PLANNING COMMISSION AGENDA April 14, 2016 7:00 PM NEWBERG PUBLIC SAFETY BUILDING 401 EAST THIRD STREET

PLANNING COMMISSION STAFF REPORT CHEHALEM AQUATIC & FITNESS CENTER CONDITIONAL USE PERMIT/DESIGN REVIEW/CODE ADJUSTMENT

HEARING DATE:	April 14, 2016	
FILE NO:	CUP-16-001/DR2-16-001/ADJC-16-001	
REQUEST:	Conditional use permit/design review/code adjustment request to approve the remodel and expansion of the Chehalem Aquatic and Fitness Center, and a code adjustment to reduce the amount of required parking.	
LOCATION:	1802 Haworth Avenue	
TAX LOT:	3217CA-1200	
APPLICANT/OWNER: Chehalem Park & Recreation District (CPRD)		
ZONE:	R-1 (low density residential)	
PLAN DISTRICT:	P (parks) and LDR (low density residential)	
OVERLAYS:	none

12.23.15 100% SCHEMATIC DESIGN Drawing: SITE PLAN LIGHTING 1493 Job No: 12.23.2015 Date: Drawn By: Checked By: Sheet No:

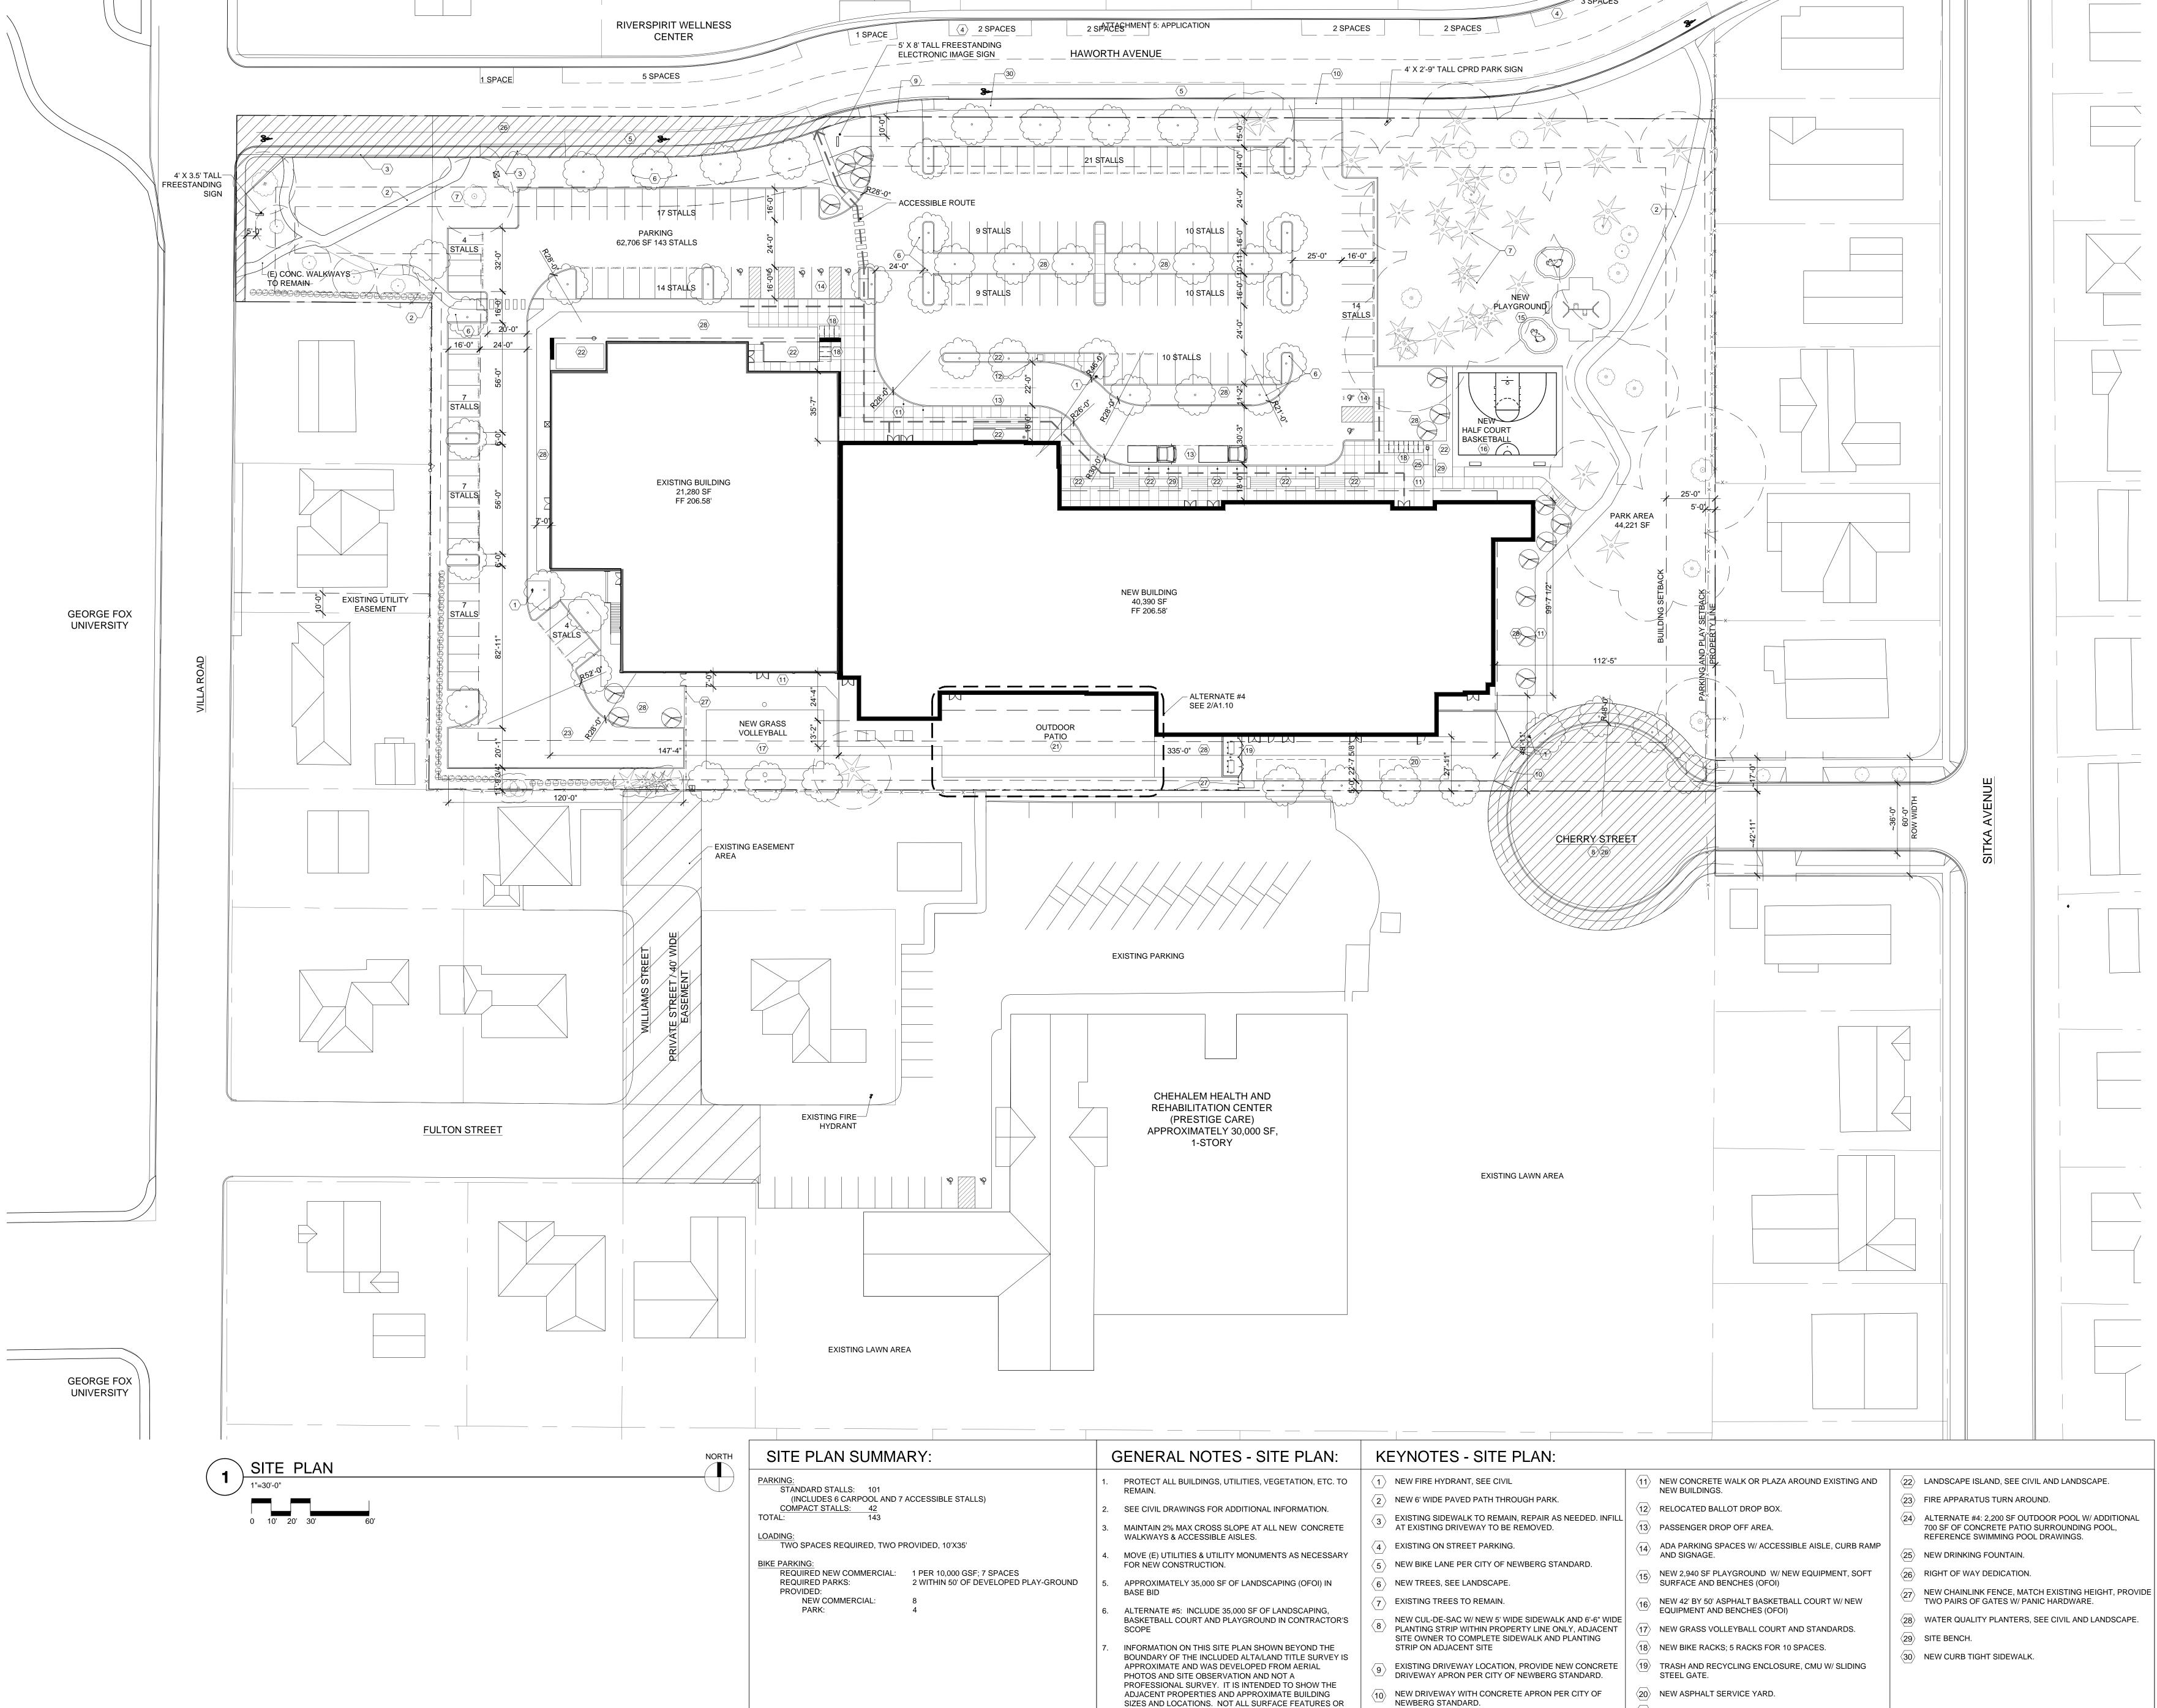
- 3. **Compatibility:** The applicant's lighting plan meets the city light trespass limits along most of the property lines, but will need to be revised in the SW and NE corners to protect residential properties from light trespass. The applicant is adding landscape buffers along the west and south property lines, and has a park area buffering the eastern property line. The request to move the playground area to the west has some tradeoffs; while it would move the playground farther from residential properties, it would remove approximately 8 mature trees and put the playground near a busy parking lot.

Light trespass: The applicant's lighting plan shows that the fixtures will be shielded and will meet the light trespass standard (cannot exceed 0.5 foot-candles) along most of the property lines, except in the NE and SW corners. <u>Submit a revised lighting plan that meets the 0.5 foot-candle light trespass</u> standard along all of the property lines, including the NE and SW corners.
